**Kenai Hydro, LLC**

**RE: Updated Project Description and Issues List for the Falls Creek (Project No. 13211)  
and Grant Lake (Project No. 13212) Hydroelectric Project**

**Attachment 1**  
**Revised Section 3.1 – Section 3.3 of Pre-Application Document**  
**(Originally Submitted August 6, 2009, revised May 3, 2010)**

**Figure 3.2-1. Proposed Project facilities and land ownership (Revised May 3, 2010).**

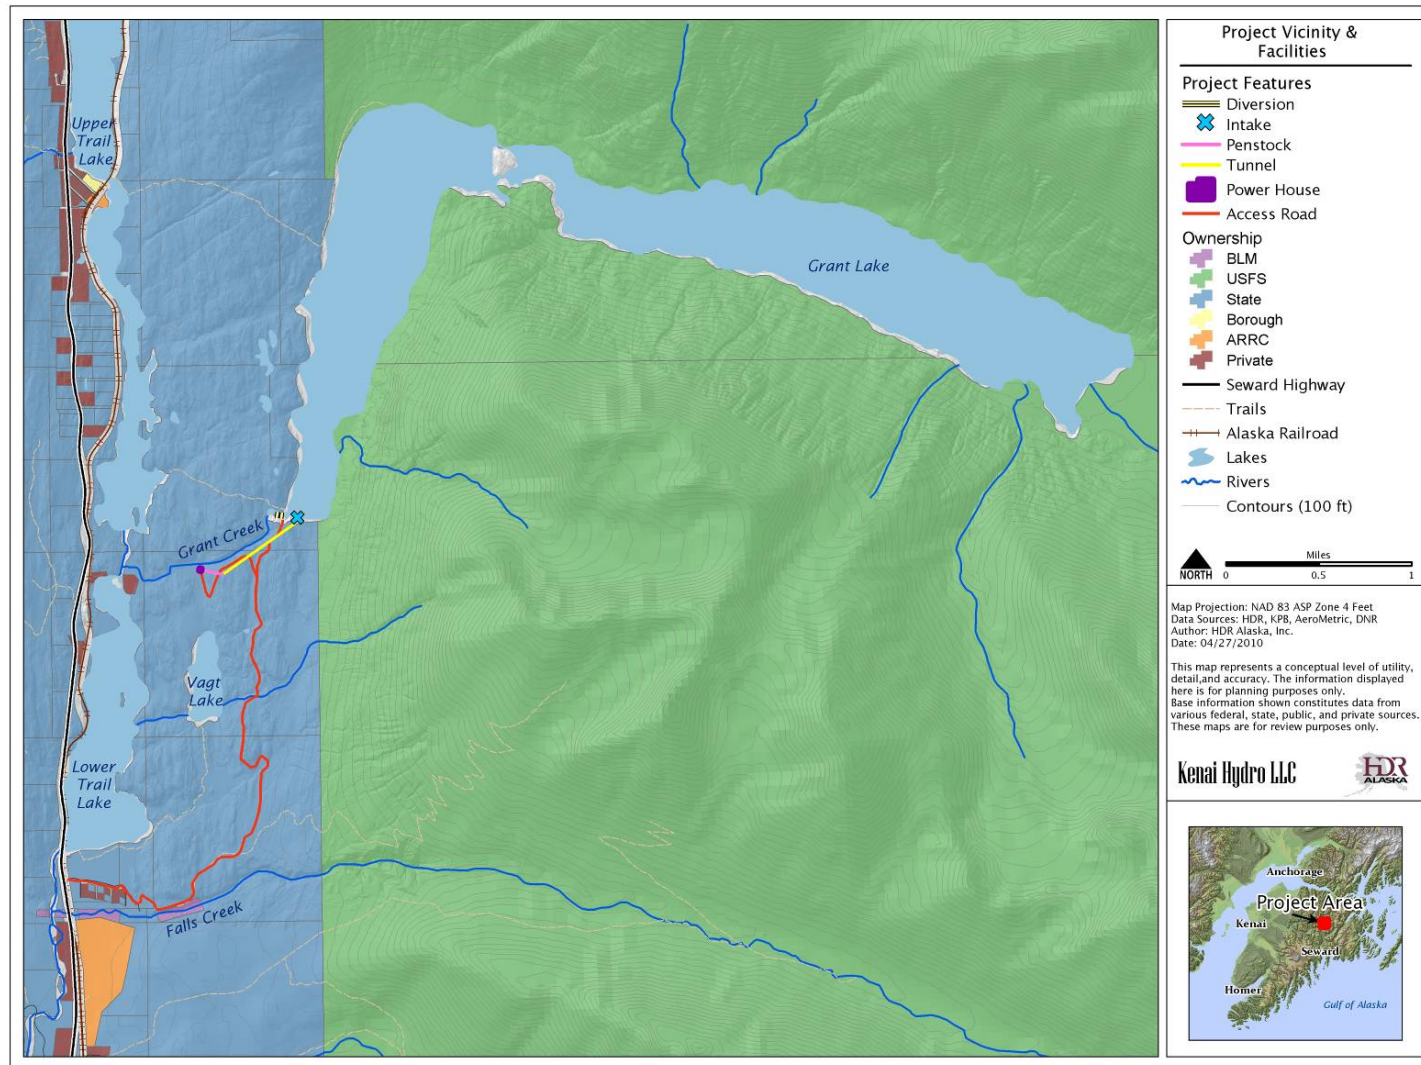
Land ownership and the proposed locations for Project facilities are shown in Figure 3.2-1.

KHL was issued a preliminary permit to investigate a proposed hydropower project on Falls Creek. The PAD filed with FERC on August 6, 2009 contemplated combining the Falls Creek development with the Grant Lake/Grant Creek development, to divert water from Falls Creek via an approximately 13,000-foot-long pipe into Grant Lake to create increased generation capability at the proposed generation facility located on Grant Creek. This diversion and associated facilities are no longer being considered as a part of the proposed Project.

The Project will consist of the Grant Lake/Grant Creek development, including an access road near Falls Creek and an underground or overhead transmission line from the powerhouse, paralleling the access roads, that interconnects at or near Lawing substation. The Grant Lake/Grant Creek development is comprised of a diversion dam at the outlet to Grant Lake, an intake structure in Grant Lake, a tunnel, a potential surge tank, a penstock, a powerhouse, access roads, a step-up transformer, a breaker, an overhead or underground transmission line, and a switchyard. The powerhouse will contain two Francis turbine generating units with a combined rated capacity of 4.5 MW with a total design flow of 350 cfs.
